CRA Design Review Committee  
Held Virtually on Zoom  
Meeting Notes  
Date: June 7, 2023

## ART INSTALLATION AT THE BROAD INSTITUTE LOCATED AT 415 MAIN STREET

## GALAXY PARK CONCEPT DESIGNS FOR STREETScape AND PARK

# GALAXY PARK - PARK DESIGN 2 "THE GROVE"

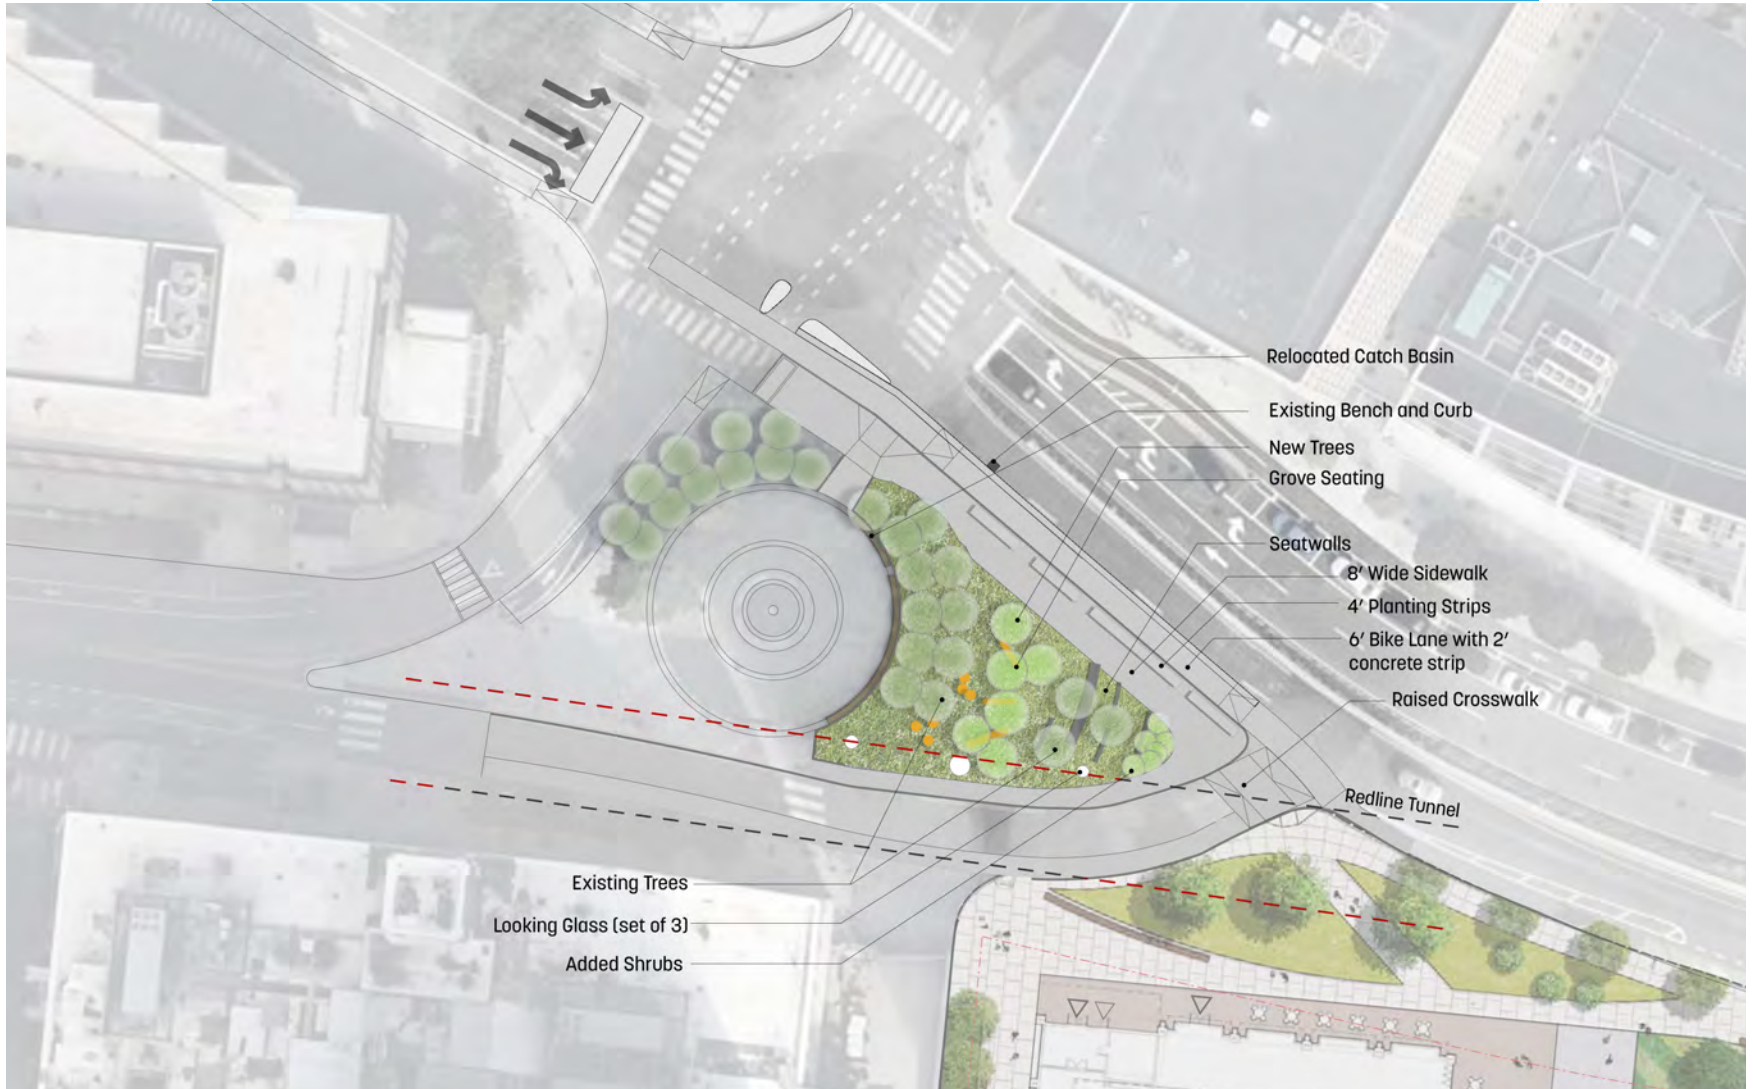
Mr. Zevin stated that all the concepts presented were better than previous efforts by past consultants. He stated that he would vote strongly for park design #2, which is the “Grove” concept. The “Seating at the Point” option made little sense as it does not seem like an attractive place to provide seating. The “Canyon” concept was intriguing but took away valuable park space to provide a desire line that was not in demand or of much use. Mr. Zevin was surprised the Fire Department was comfortable with the proposed streetscape designs given the major trauma center on the other side of the Longfellow Bridge and the tendency for traffic to back up to this roadway. Mr. Zevin expressed a desire to resolve an existing pinch point in the contraflow bike line located on Main Street to the west of the park. He reaffirmed his preference for the Grove park concept but indicated a dislike of flex-post separated bicycle facilities as they are easy to run over with motorized vehicles. He suggested that a mountable curb may be a better solution.

Ms. Born agreed with Mr. Zevin that the “Seating at the Point” concept should be ruled out. She expressed some interest in the “Canyon” concept but ruled it out, agreeing with Mr. Zevin that it made little sense to make such an intervention when there wasn’t a strong existing desire line. Ms. Born asked if a raised cycle track would be demonstrably safer than a flex-post separated bicycle lane and also asked how long this section of road redesign would be. Mr. Engler responded that it was likely a few hundred feet in length. Ms. Born continued with asking whether this section of street was a particularly dangerous area on bicycle and that, if so, she could see the rationale for a raised cycle track. In general, however, Ms. Born felt that an at-grade bicycle facility would fit the overall point-of-view of the area’s urban design better. She noted that the Longfellow Bridge also has at-grade flex-post separated bicycle lanes and that while grade-separated facilities are considered best standard, flex-post separated facilities suffice as a solution in many places. Ms. Born asked if the “Grove” park concept could be paired with either streetscape concept, which Mr. Engler confirmed.

Ms. Born and Mr. Zevin concurred that their preferred park concept alternative was the "Grove" concept, and that they both preferred different alternatives for the streetscape design. Mr. Evans

# GALAXY PARK – STREET DESIGN 2 RAISED CYCLE TRACK

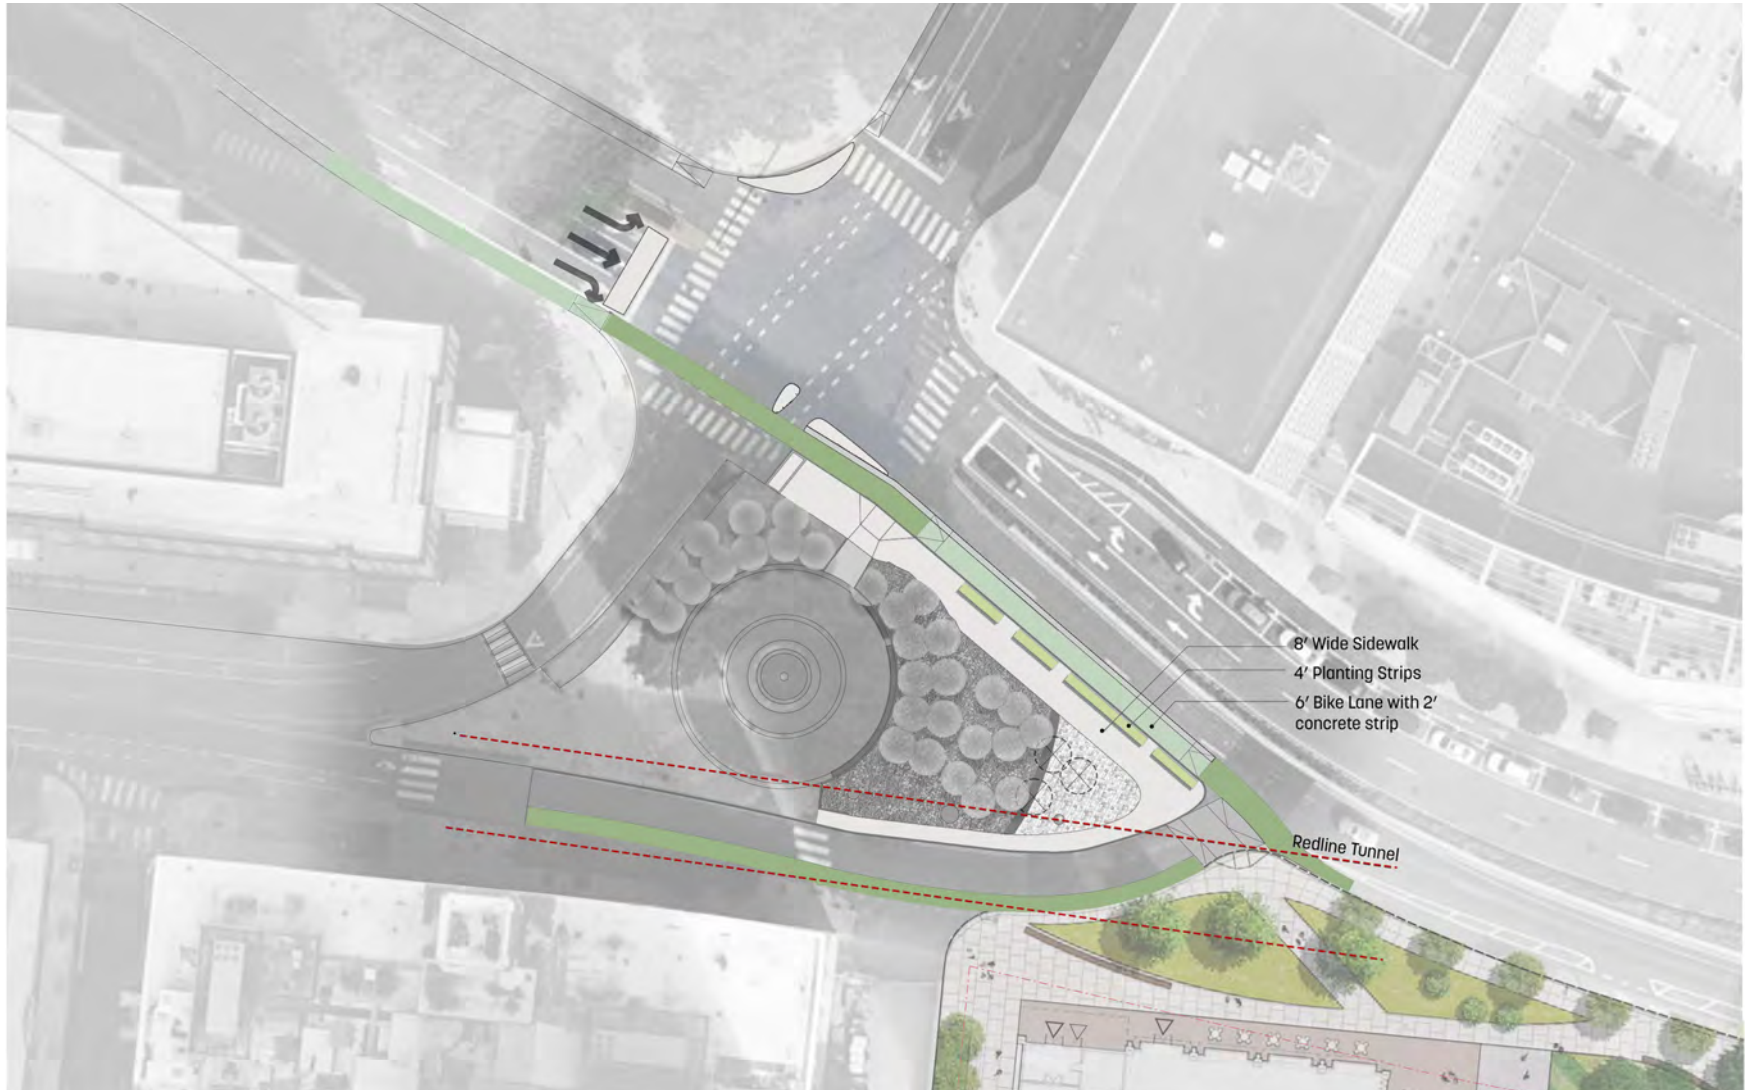
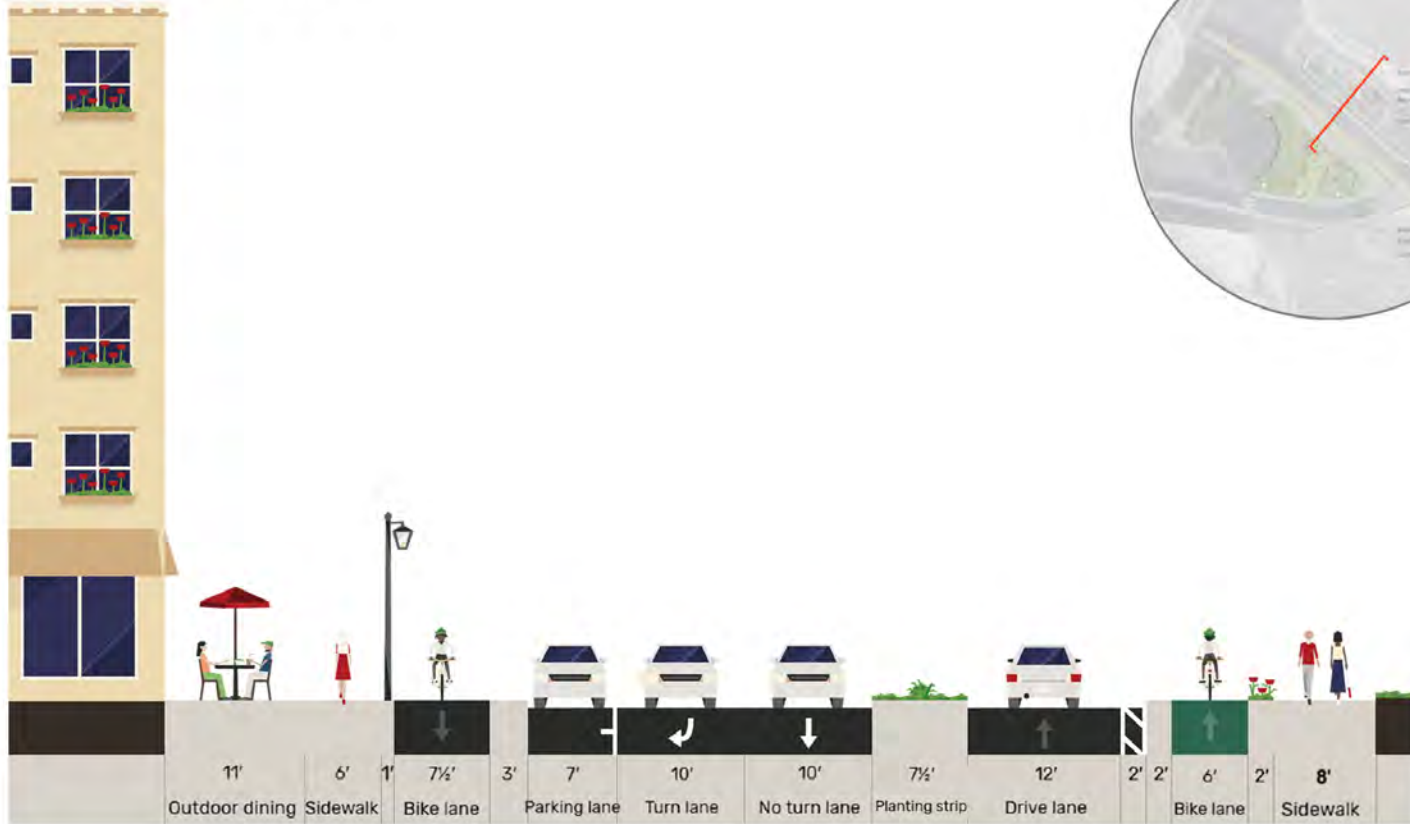
Mr. Evans provided some additional context that the stretch of Broadway from Ames to Third Street will eventually have a raised cycle track on both sides due to a nearby development project by MITIMCo and, likewise, Boston Properties is responsible for building a raised cycle track from Galileo Galilei Way to Ames Street. While this segment of road is small in comparison, Mr. Evans noted that the CRA feels responsibility for bringing it up to the standards of the broader streetscape. Ms. Born thanked Mr. Evans and shared that this information changed her perspective. She asked to clarify whether Broadway to the east and Main Street to the west would be a continuous raised cycle track in the future, and Mr. Evans answered that while Broadway is planned to have a raised cycle track, Main Street to the east is flex-post protected and no plans currently exist to change this condition. Ms. Born stated that if any road in the City of Cambridge is to have a premier bicycle lane facility, this road should be it since it has the highest bicycle traffic volumes in the city.

Mr. Zevin stated that this section of roadway is also of primary importance for emergency vehicle access, and that we should not compromise on ensuring an ambulance or a firetruck would be able to squeeze past a row of stopped cars. Mr. Zevin suggested that the ample space provided to flowers, the bike lane, and the sidewalk could be reduced to not impede with the needs of emergency vehicles. He referenced a raised cycle track facility on Vassar Street that has no separation between the bicycle lane and sidewalk and that conditions there appear okay. He suggested that a mountable curb on the lane may allow for emergency vehicle access along the street segment.

stated that the design team will take the priorities and feedback offered in this meeting to the City and the Fire Department and return to the Board at a later date with answers surrounding emergency vehicle access and different alternatives.
